# Park District of Highland Park

## 2021 Sunset Valley Golf Club Cart Path Bridge Fabrication

### **ADDENDUM # 2**

October 22, 2021

**GENERAL DETAILS**

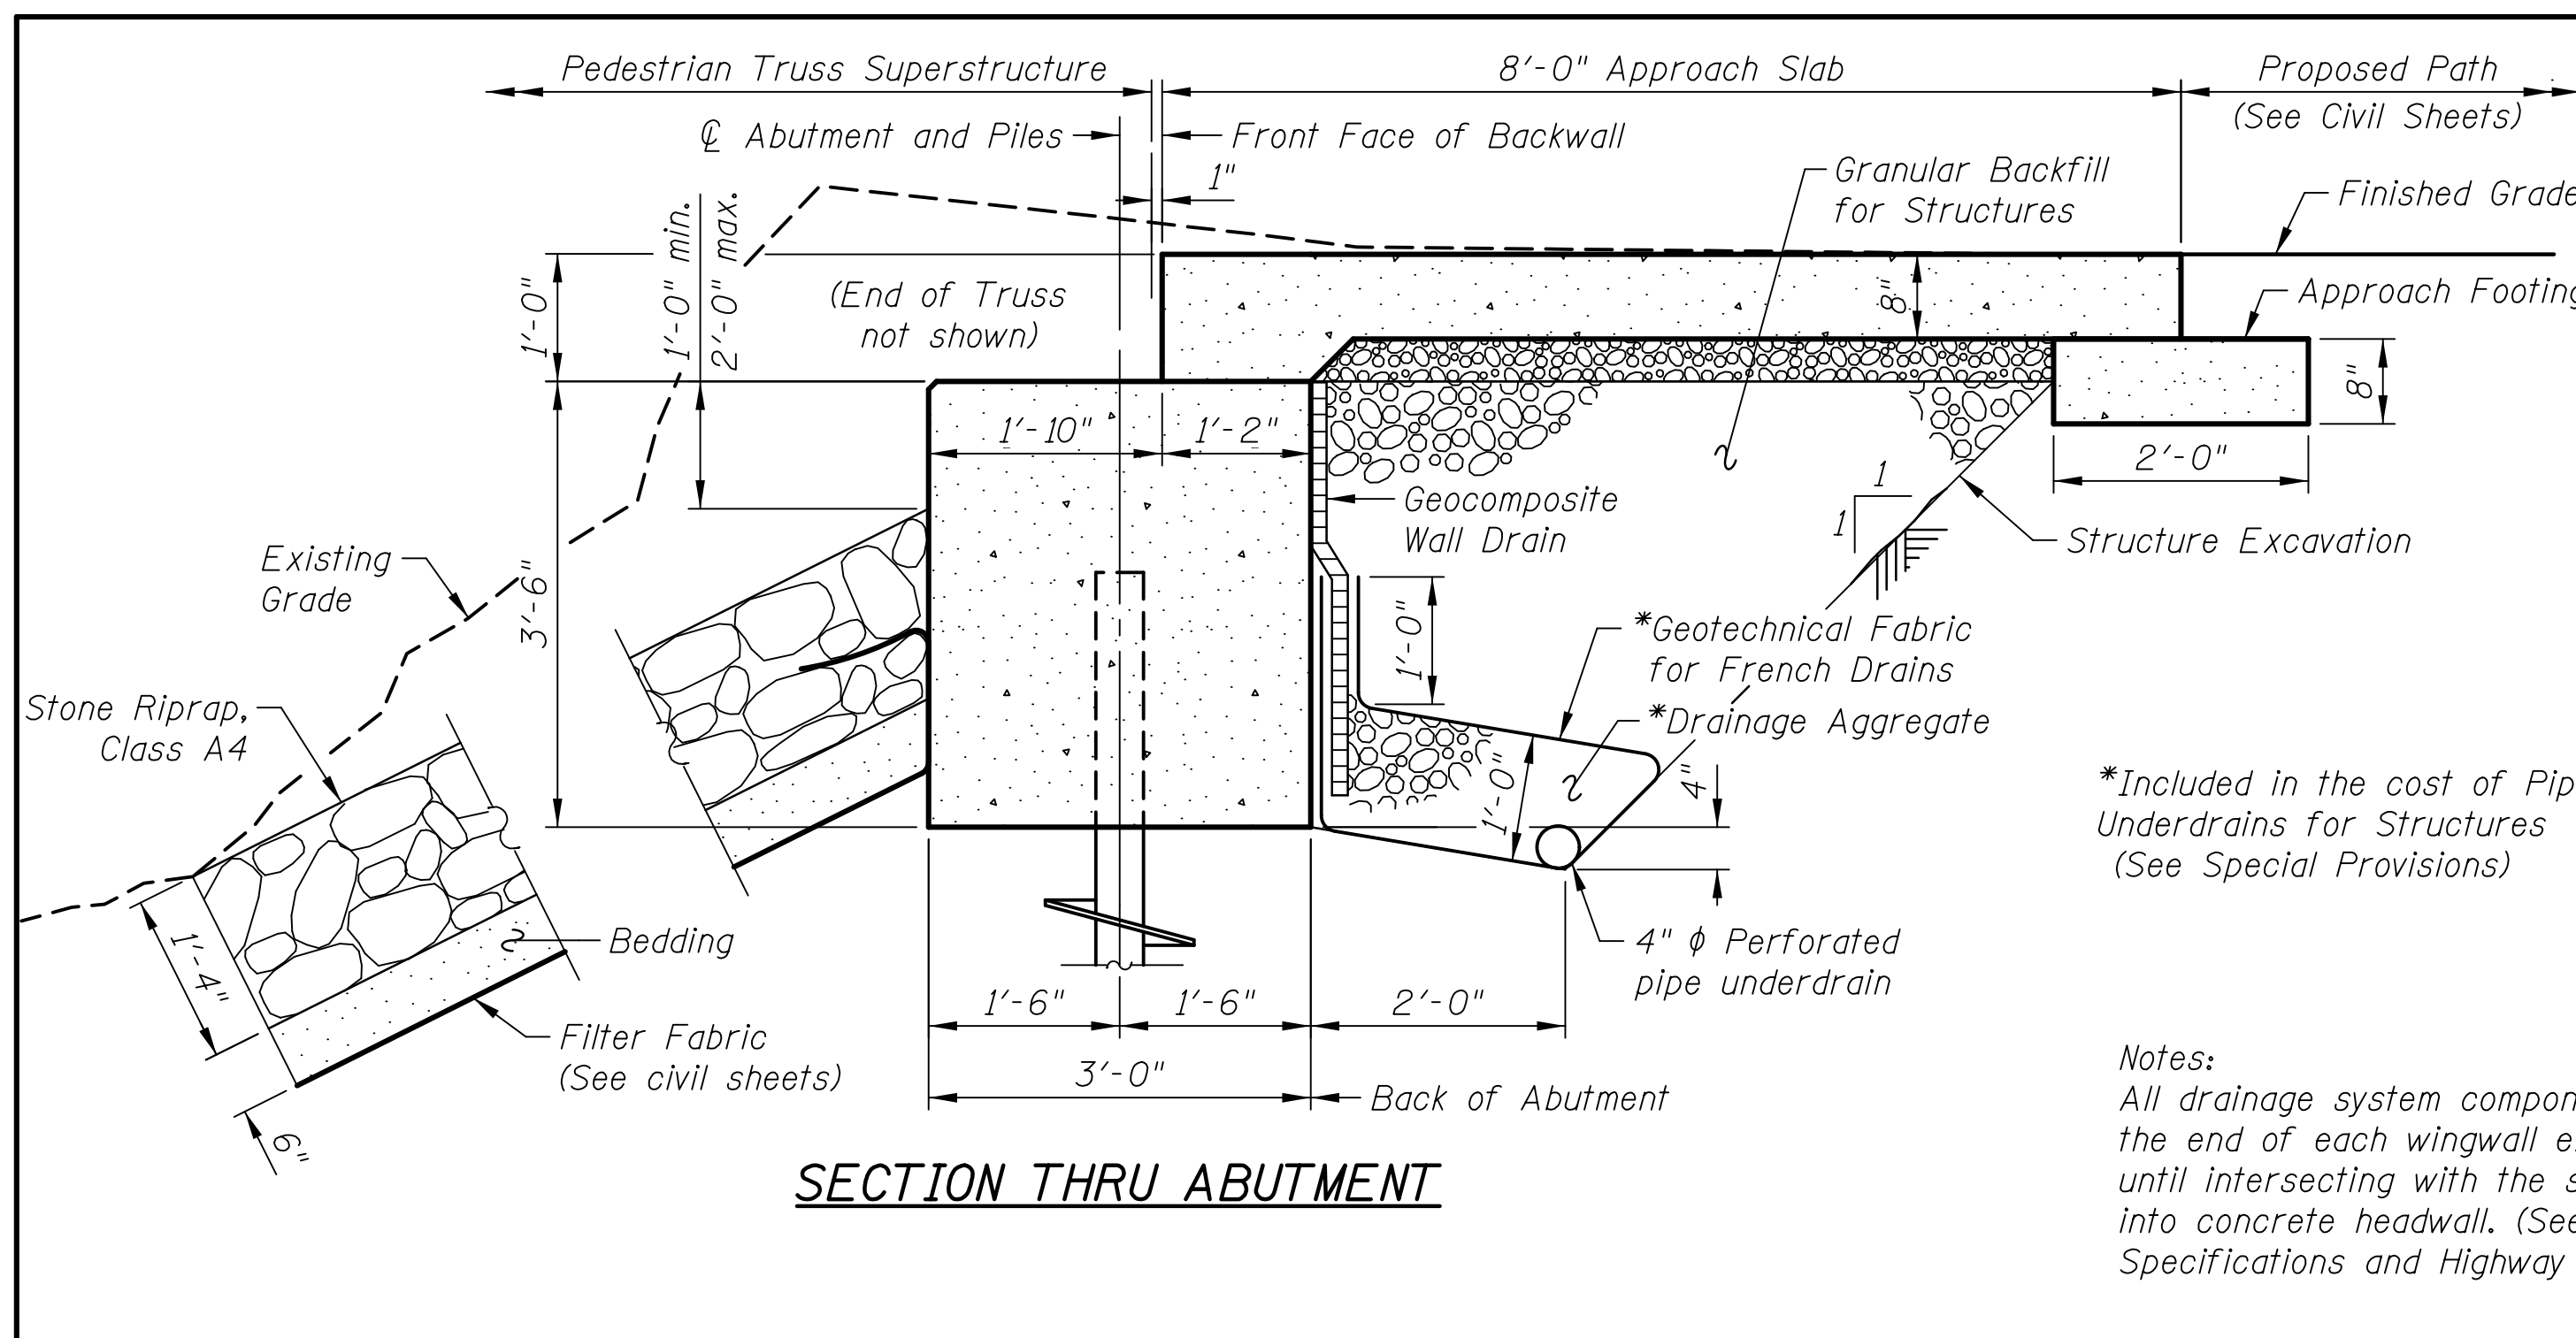
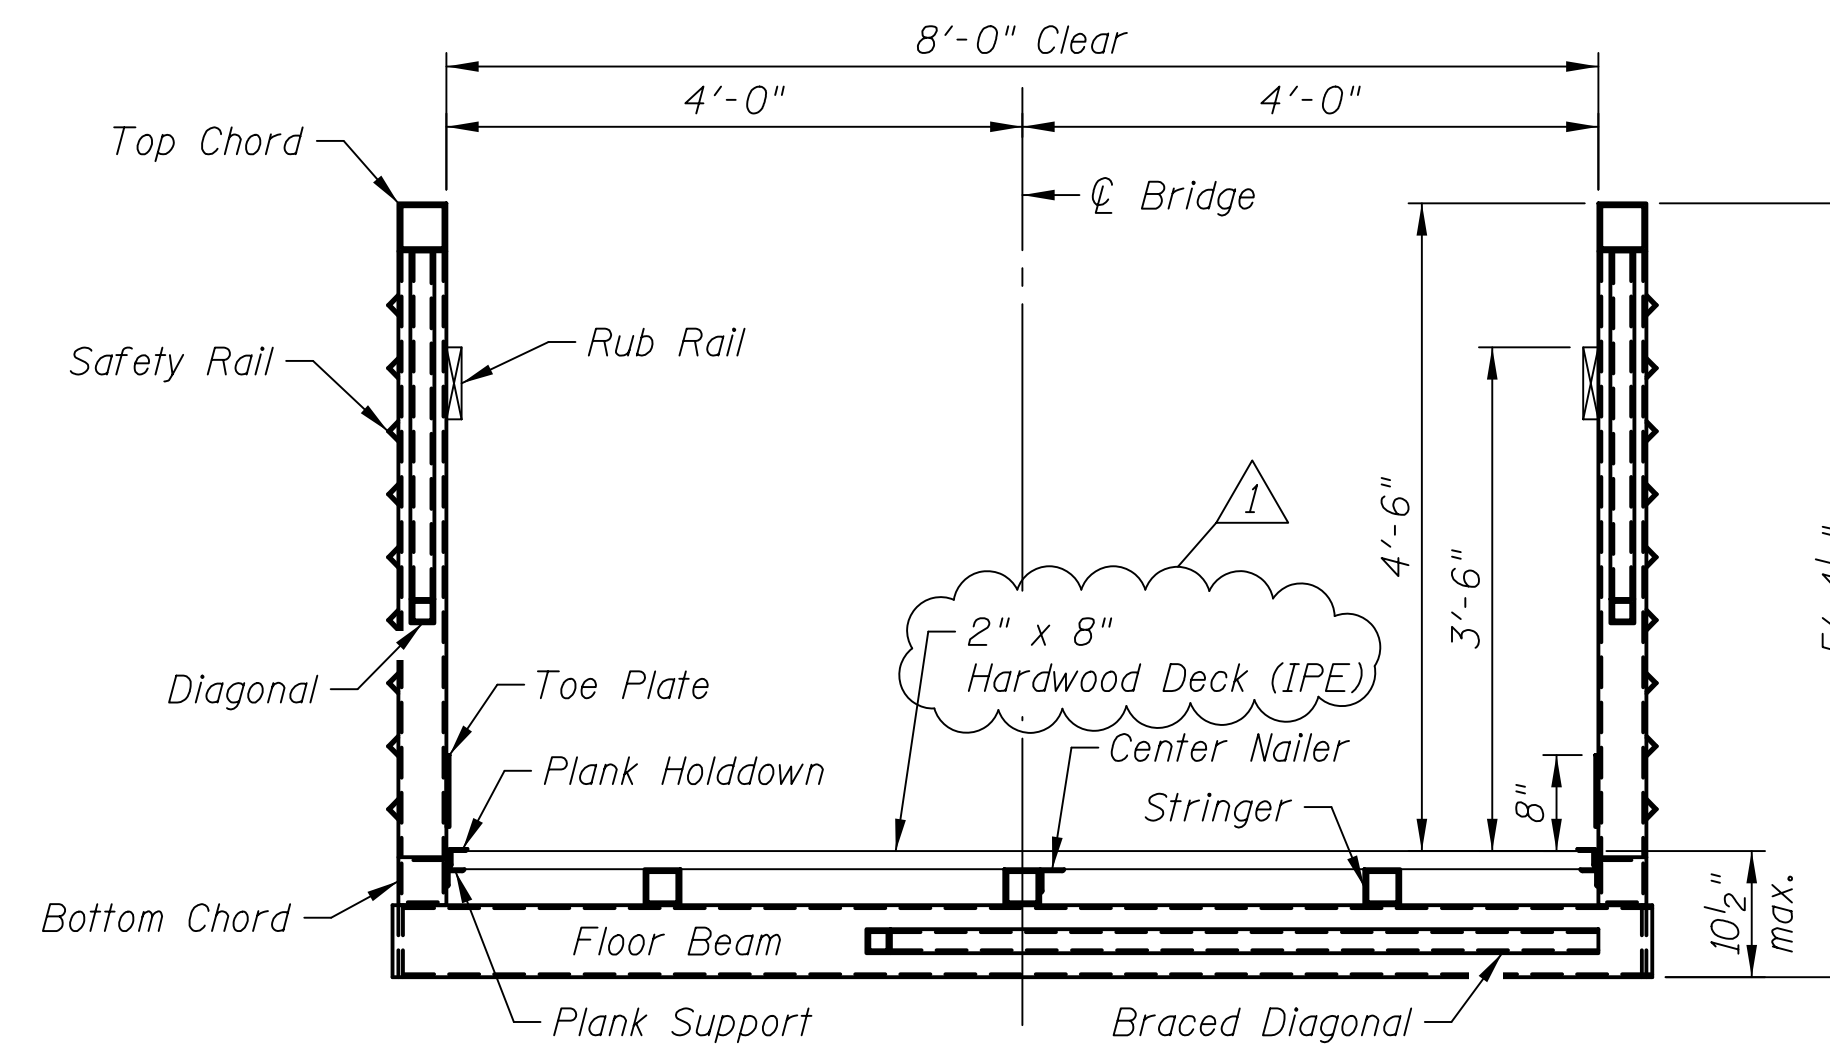
Change has been made to General Notes 1 on Sheet S-7. Updated Sheet S-7 attached.

- Truss shall use steel that meets the requirements for AASHTO M270 Grade 50, and ASTM A847 or ASTM A500 Grade C. High strength bolts shall conform to ASTM A325 (Type 1). Where special provisions and these plans differ, these plans shall govern. Bolt size shall be determined by the Contractor.
